BRUNSWICK STEAM ELECTRIC PLANT, UNIT 1

Amendment No. 106  
License No. DPR-71

ATTACHMENT TO LICENSE AMENDMENT NO. 106

SAFETY EVALUATION BY THE OFFICE OF NUCLEAR REACTOR REGULATION  
SUPPORTING AMENDMENT NO. 106 TO FACILITY OPERATING LICENSE NO. DPR-71  
CAROLINA POWER & LIGHT COMPANY  
BRUNSWICK STEAM ELECTRIC PLANT, UNIT 1  
DOCKET NO. 50-325

FIGURE 3.1.5-1

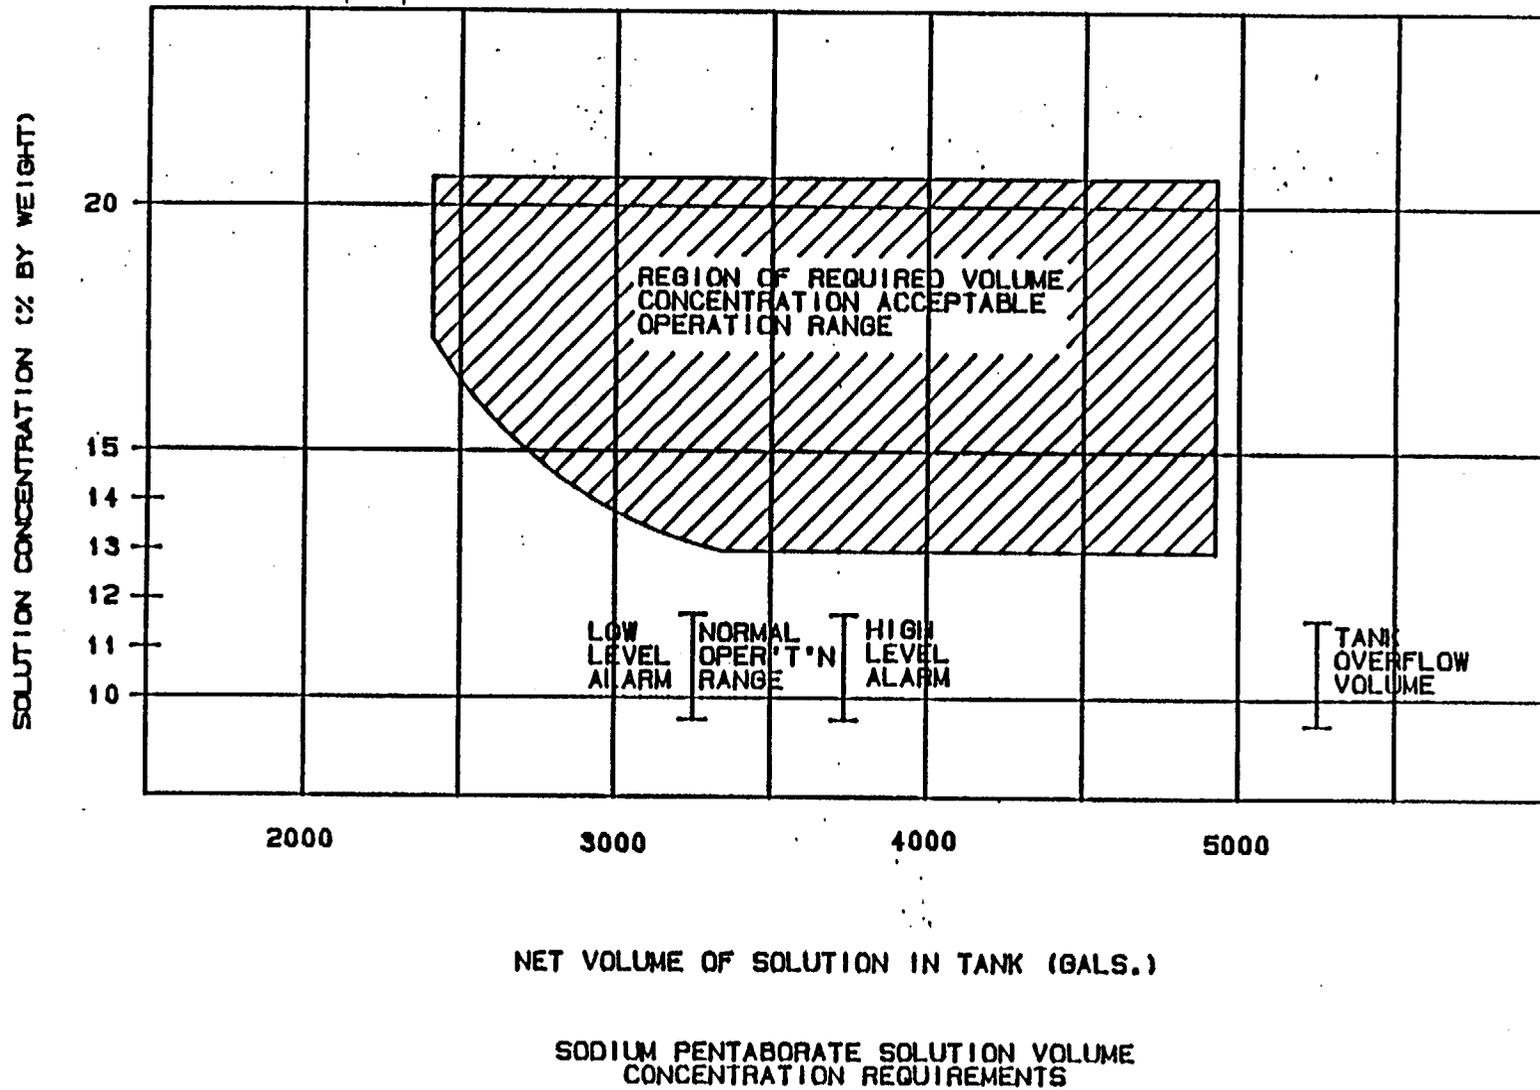
The amendment changes Section 3/4.1.5 of the Technical Specifications by revising the standby liquid control system (SLCS) pump relief valve setpoint and the sodium pentaborate solution concentration curve to satisfy the ATWS rule requirements specified in 10 CFR 50.62. In addition, the SLCS pump flow surveillance requirements are clarified.

The changes proposed by the licensee have been reviewed by the staff against the requirements of the ATWS rule (10 CFR 50.62), and Generic Letter 85-03 "Clarification of Equivalent Control Capacity for Standby Liquid Control Systems" dated January 28, 1985. The licensee's proposed increase in sodium pentaborate concentration to 13 weight percent in conjunction with a flow rate of 66 gpm and a reactor pressure vessel inside diameter of 218 inches, will provide a boron content equivalent in control capacity to 86 gpm of 13 weight percent sodium pentaborate for a 251 inch inside diameter vessel. This is in compliance with 10 CFR 50.62 and is therefore acceptable.
